Overview

- Overarching Issues
 - Staff's Role
 - Clarification of IDWR Drawdown Analysis
- Address April 1, 2009 Response to Staff Memorandum

- Review submittals/conduct analyses to address topics identified by Hearing Officer
 - Identify inconsistencies w/ bearing on:
 - Hydrogeologic conceptual model
 - Assessment of hydrologic impacts
- Neutral party

Figure 6. Cooper-Jacob Analysis for the Big Gulch Stock Well with Water-Level Trend Corrections

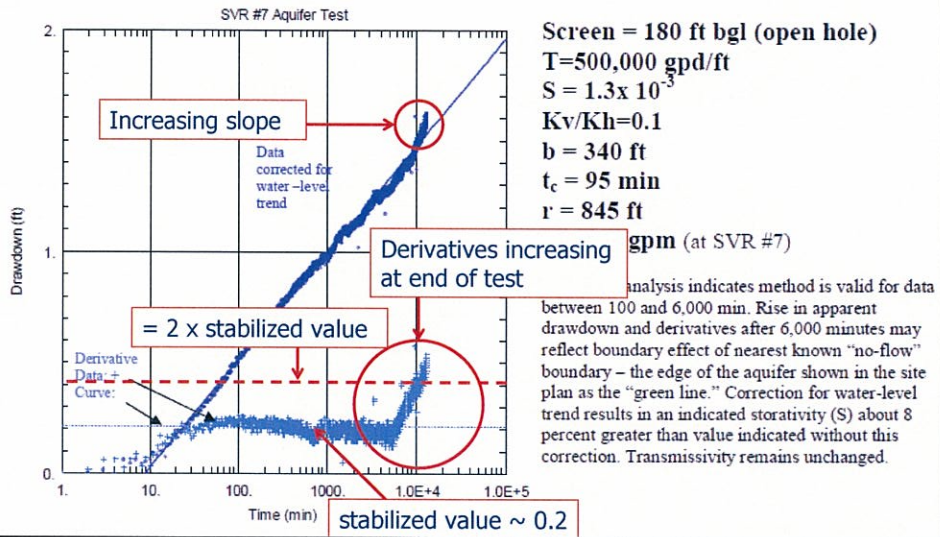
- Regardless of scale, staff believes SVR#7 test ended prematurely and with inconclusive results
- Staff disagrees with HLI opinions:
 - *"extending the test would have added no significant information"* (Exhibit 45, p. 23)
 - *"Adjusting the drawdown data from the Big Gulch stock well to correct for this trend...generated a drawdown plot (Figure 6) with almost all of the apparent end-of-test increase in drawdown removed"* (Exhibit 45, p. 23)

EXHIBIT 44

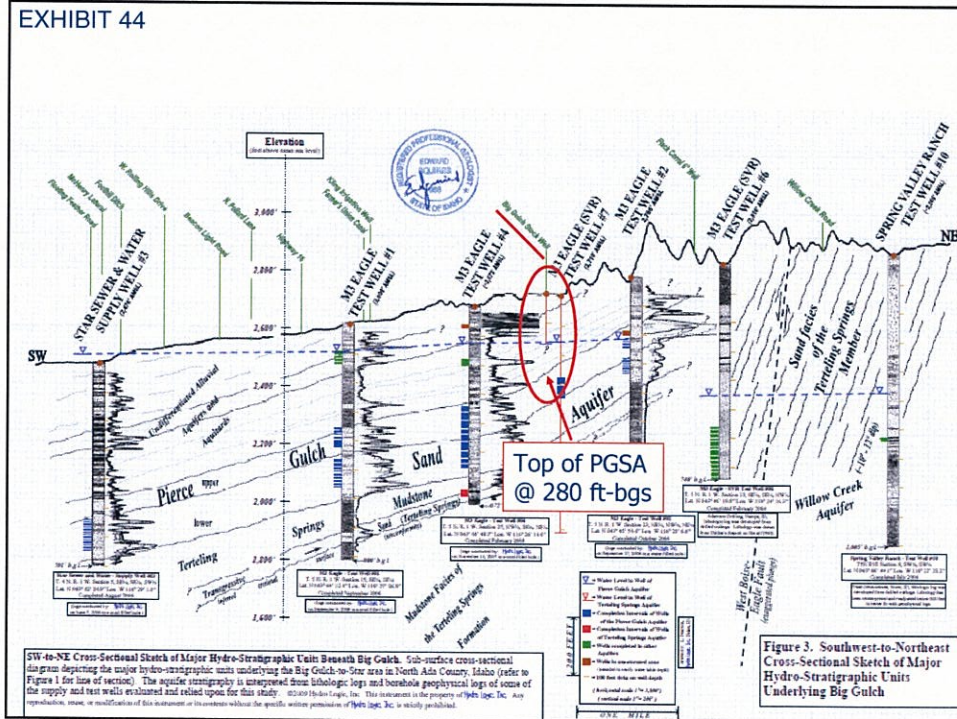
- Big Gulch Stock Well
 - Closest observation well and only well w/ more than 1 foot of drawdown (~1.7 ft.)
 - 180 ft. deep
 - Thought to be open hole completion
- PGSA extends from 180 to 520 ft-bgs (Exhibit 44, Table 1)

- HLI on data from the Big Gulch stock well:
 - “One potential issue with the interpretation of the data from the Big Gulch Stock Well is that it may be completed about 100 feet above the top of the Pierce Gulch Sand Aquifer. Our interpretation of the geophysical logs from SVR#7 indicate that the top of the Pierce Gulch Sand Aquifer lies approximately 240 feet below ground level while the limited information we have available for the Big Gulch Stock Well suggest it is completed (and open to an aquifer) 180 feet below ground level. Although this apparent discrepancy might be considered a complication, we believe it neither invalidates the analysis of data from this well nor our interpretation of aquifer properties...” (emphasis added, Exhibit 44, p. 30)

Figure 5. Geologic Cross-Section through the M3 Eagle Site

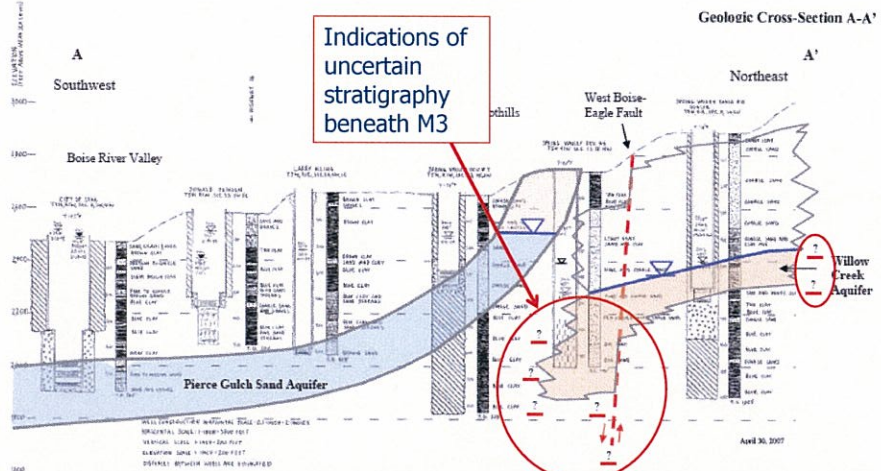
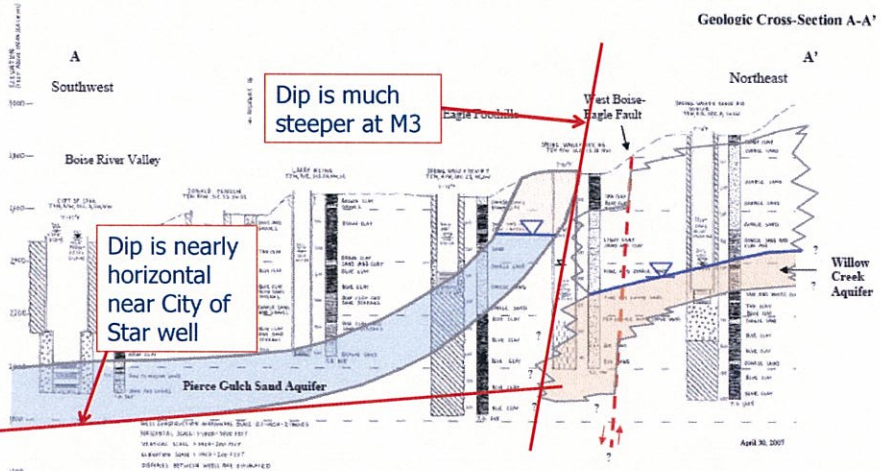
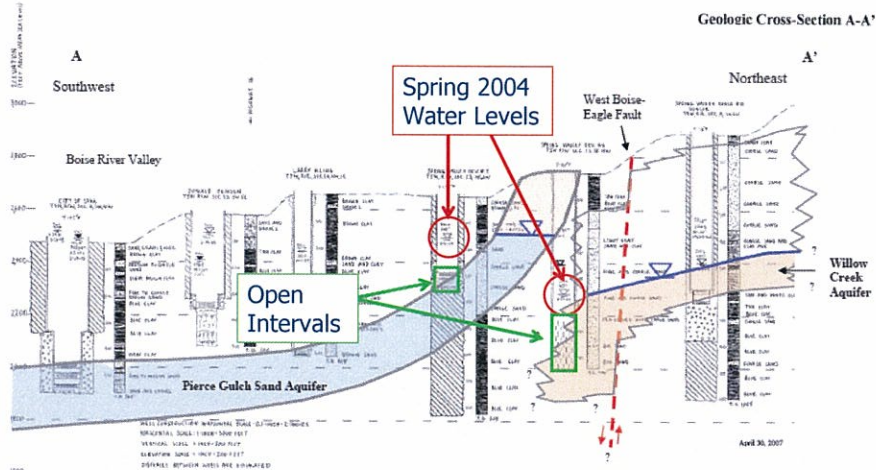
- None of the geologic cross-sections in Exhibit #27 identify formal geologic units or correlate stratigraphy between boreholes.

Figure 5. Comparison of Water Level Responses in TW #1 and TW #4
From Continuous Water Level Monitoring
Monitored For M3 Eagle By: Hydro Logic, Inc.

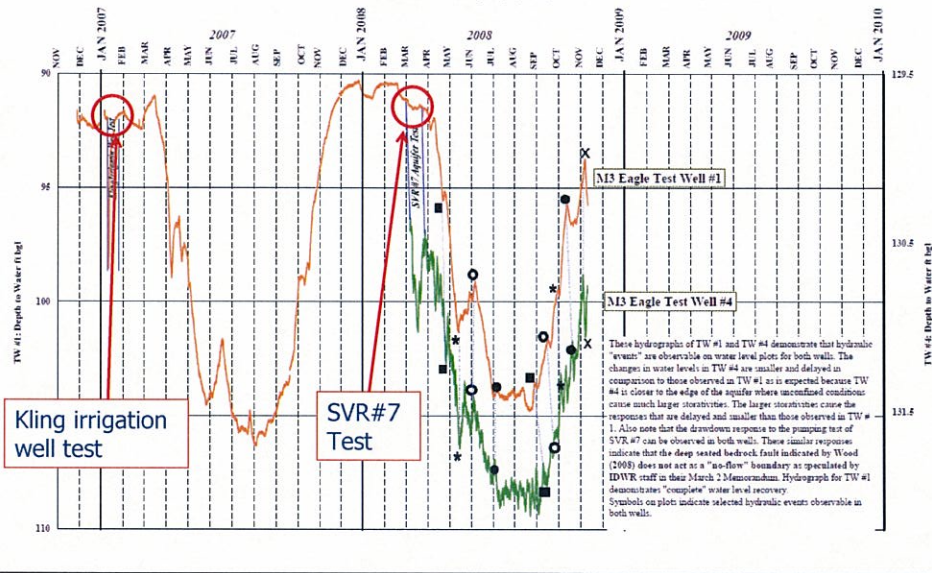
- HLI's response to Staff's concerns about water level recovery:
 - *"HLI has explained why the water levels in measured wells did not recover to pre-test levels during the recovery measurement period, including the annual fluctuation in regional water levels shown in all monitored wells in the area. It would be unusual (and a contradiction to standard well recovery analyses using methods based on the Theis equations) for water levels in Boise River Valley wells to fully recover in hydraulic tests within the same amount of time as the drawdown occurred. However, to assure IDWR that the aquifer did indeed recover, the attached Figure 5 shows that the water levels in TW#1 (completed in the PGSA about 50 feet from the Kling domestic well) recovered within 2 weeks."* (Exhibit 45, p. 19).

Figure 26. Theis Recovery Analysis for the Big Gulch Stock Well with no Water-Level Trend Correction

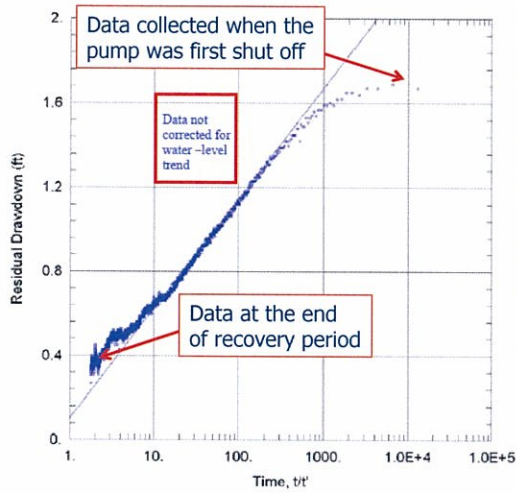
S/S' less than 1 suggests "late" or "incomplete" recovery. However, seasonal (declining), regional, water-level trend over 12 days of recovery is most probable cause of apparent incomplete recovery.

Figure 27. Theis Recovery Analysis for the Big Gulch Stock Well with Water-Level Trend Corrections

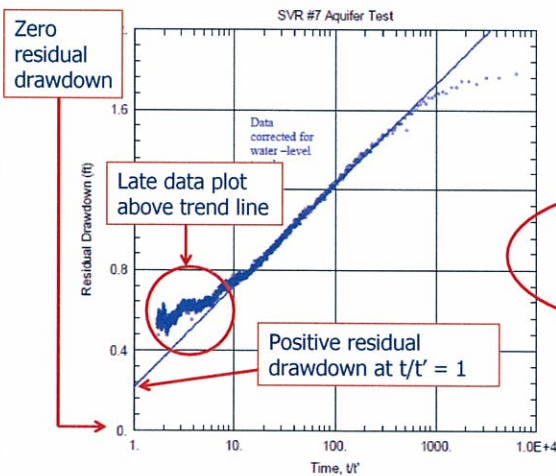
HLI's analyst describing trend-corrected water level recovery plot

S/S' less than 1 suggests "late" or "incomplete" recovery. However, incomplete correction for seasonal (declining), regional, water-level trend over 12 days of recovery is most probable cause of apparent incomplete recovery.

Figure 7. Theis Recovery Analysis for the Big Gulch Stock Well with Revised Water-Level Trend Correction

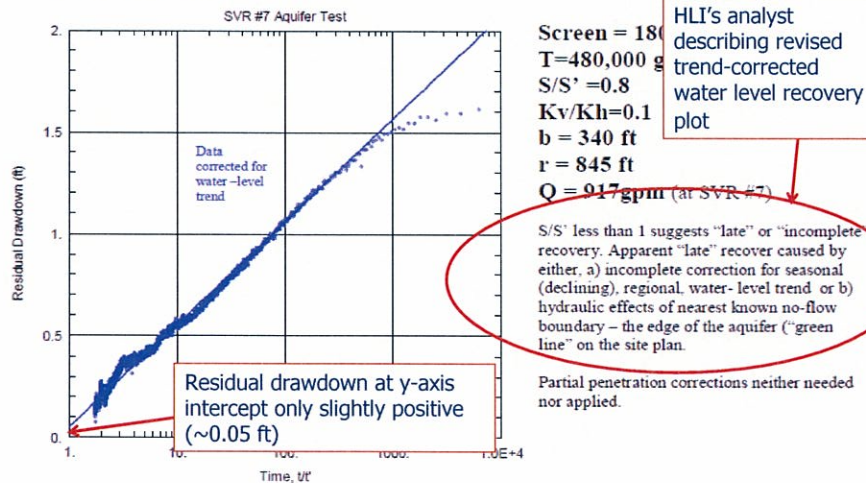
- HLI's description of water level trend correction:
 - *"We inadvertently omitted a minus sign to the correction... By applying the minus sign to the correction, the revised recovery plot (Figure 7 below) now projects close to the total recovery point of the graph, as is expected through standard well pumping and recovery theory (Theis, 1935). The small difference between the actual plot and a perfect projection may be the result of incomplete correction for trend or it could be the effects of the edge of aquifer boundary discussed above and noted in our reports."* (Exhibit 45, p. 24).

Figure 23. This Recovery Analysis for Well SVR #7 with Trend Correction

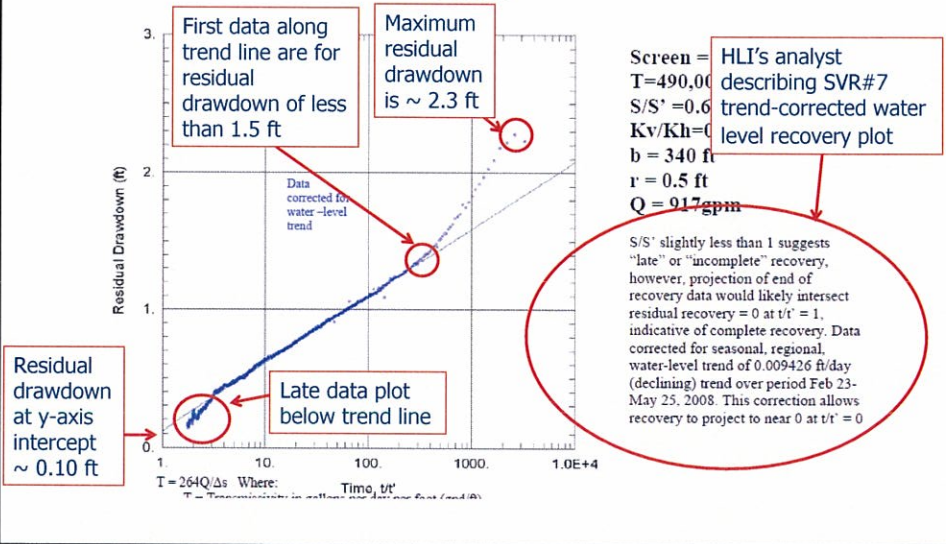
- Residual drawdown values for the pumping well during the SVR#7 test appear to be too low:
 - First data to fall onto trend line are for residual drawdown values of less than 1.5 feet
 - The maximum residual drawdown value on Figure 23 in Exhibit 44 is approximately 2.3 feet
 - Maximum drawdown in SVR#7 after correcting for well loss is 7.51 feet according to Table 2 in Exhibit 44, which is more than 5 feet greater than maximum value shown on the water level recovery plot for the pumping well
- Large unexplained discrepancy suggests that data may not be representative of water levels in the pumping well

Figure 88. Theis Analysis for TW#1 Zone 1 – Kling Irrigation Two-Day Test
Test Conducted: January 9-11, 2007

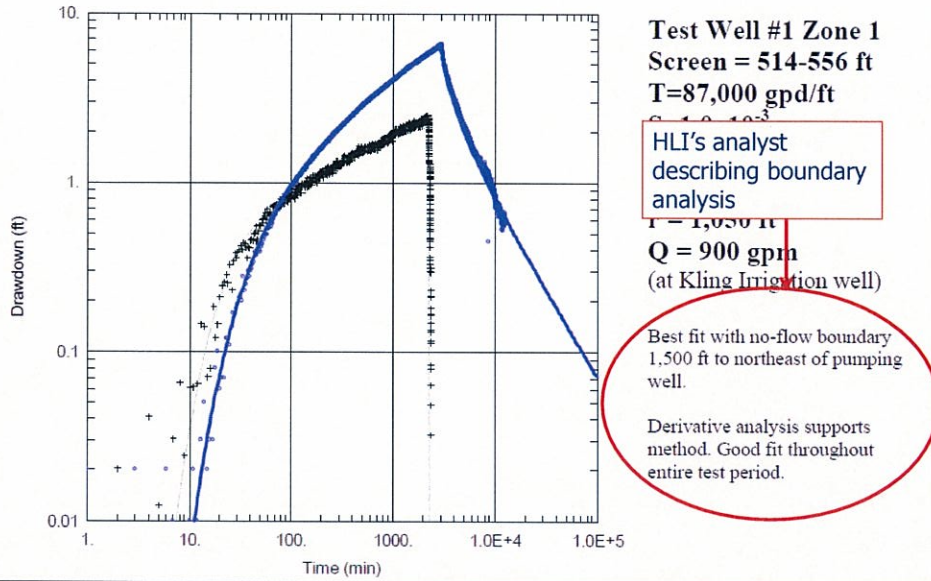
- HLI on newly identified fault:
 - *"the deep-seated bedrock fault indicated by Wood (2008) does not act as a no-flow boundary as speculated by IDWR staff"* (Exhibit 45, p. 8)
 - *"Since the Aqtesolv® analyses used to generate a curve match required the use of a fault acting as a no-flow boundary, and because other subsurface geophysical mapping by HLI suggests a buried fault trace, it appears likely that such a fault may be present in the vicinity of the Kling well and that it may control ground water movement in the aquifer to some extent."* (emphasis added, Exhibit 12, p. 212).

Figure 2. Subsurface Seismic Reflection Profiles: (from Wood)

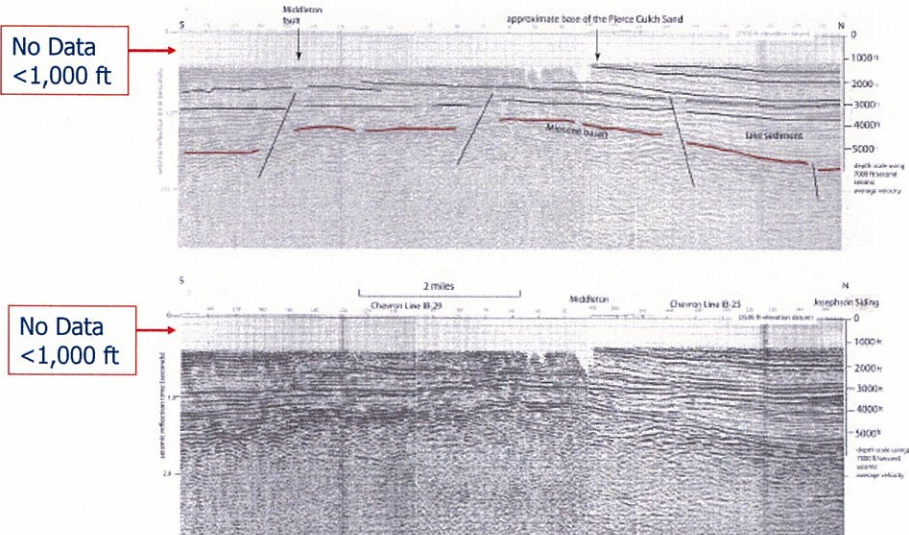
- HLI describing potential hydrologic significance of shallow faults:
 - “Major faulting that formed the western Snake Plain generally does not significantly cut or offset the younger sedimentary units (shallower than 1,000 ft) in the basin on the north side of the plain...Figure 2 shows in detail the nature of faults in the basin” (Exhibit 45, p. 9).
